Subject: Appraisal Services for SPF vehicle at INDECO - QX793S

CONTRACTOR :	Indeco Engineers Pte Ltd	VEH TYPE :	UNIT :	MARINA BAY	Reference No. MHA/SPF/2019/11-0028 1100038838
VEH NO :	QX 793 S	FRC	REPAIR TYPE:	ACCIDENT	
VEH MAKE/MODEL:	HYUNDAI AVANTE		Mileage:	110881

ACCIDENT/DAMAGE REPAIR AND AD HOC WORKS REQUEST FORM

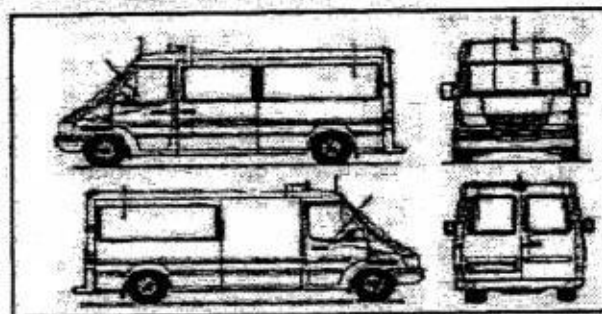
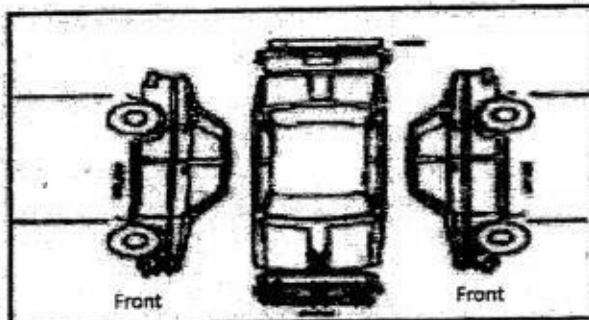
Description of affected area/required works (e.g. dented, cracked, grazed etc)

Front bumper and hood badly damaged/caved in.

Airbags deployed because of collision.
